**Review of the United States Environmental Protection Agency DRAFT Report
Entitled
"Investigation of Ground Water Contamination near Pavillion, Wyoming"**

**Encana Oil & Gas (USA) Inc.
370 17th Street, Suite 1700
Denver, Colorado 80202**

**Robert J. Sterrett, Ph.D.
Itasca Denver, Inc.
Lakewood, Colorado**

March 2012

USEPA Figure 20
Cross Section in Core Area

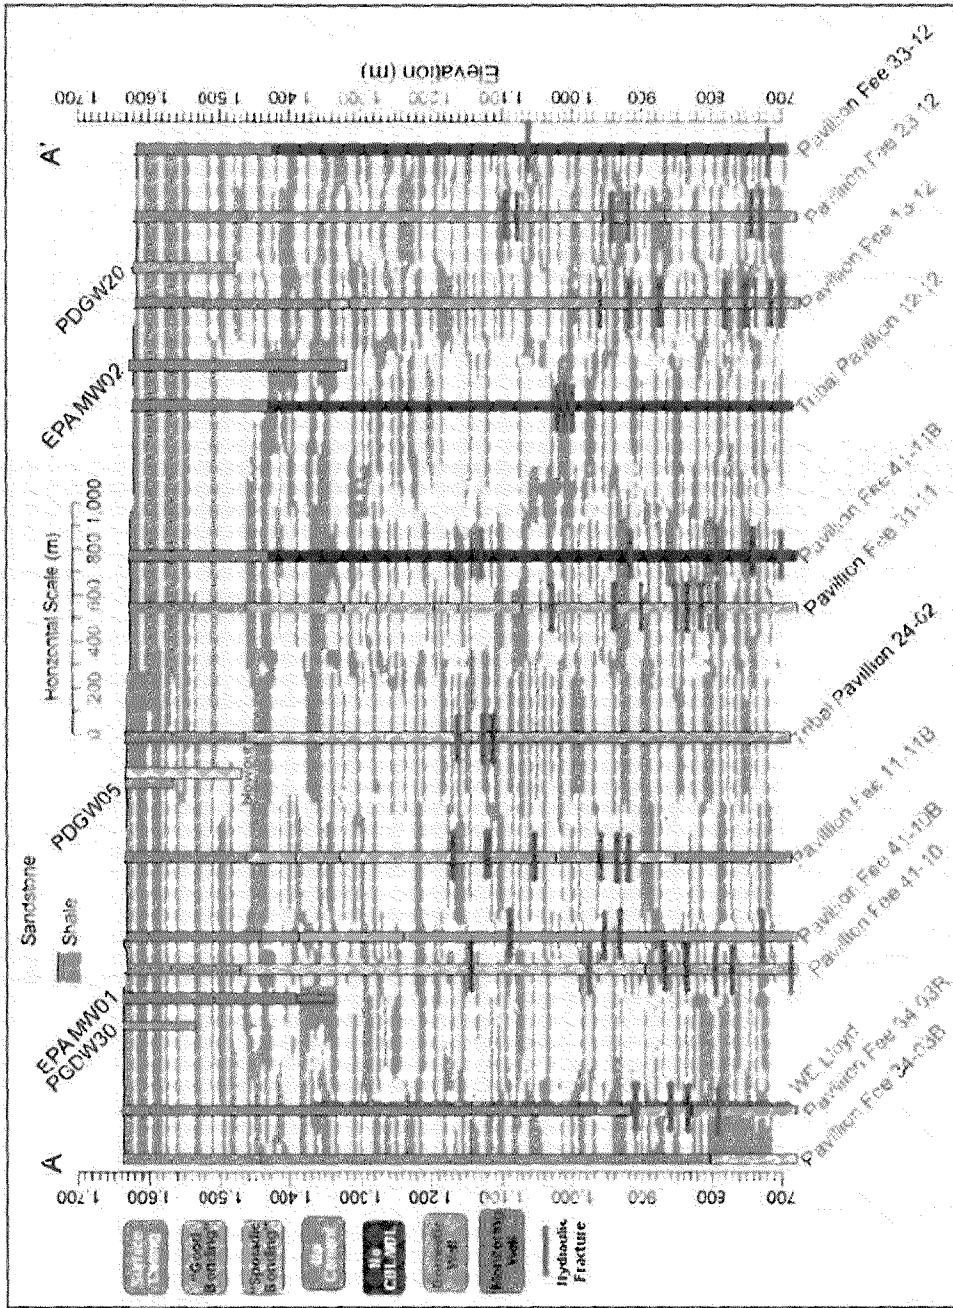
Figure 20 of the USEPA Draft Report (see Figure RJS-7 of my report) depicts there are thick, continuous sandstone layers throughout the core area especially at shallow depth. This is not the case. The quality of this figure in the Draft Report is poor, and how the correlations are derived is unknown. The geologic model shown by the USEPA in their Draft Report is counter to geologic interpretations provided by geologists working for the USGS and industry. Figure RJS-8 shows the location of USEPA's cross section superimposed upon a structural contour map of the top of the Fort Union Formation. The structural contour map has been modified from that provided by Bjorklund (1978) (Figure RJS-5) by the addition of faults. The locations of these faults have been interpreted based on additional information since Bjorklund's paper in 1978.

Figure RJS-9 is a revised cross section A-A'. In this cross section the same wells are used as those by the USEPA; however, the results of various geophysical logs have been displayed. In the Pavillion Field the Wind River Formation is approximately 3,400 ft thick. This formation is further divided into two members; a thick lower unit termed the Lysite Member and a thinner upper unit referenced as the Lost Cabin Member. The Lysite Member is the gas producing interval in the Pavillion Field. Figure RJS-9 shows the tops of perforations for the production wells included on the cross section. Porous zones in sandstone units other than the basal sandstone are limited in thickness and, in order to obtain economical quantities of gas, multiple zones may be perforated in a single well.
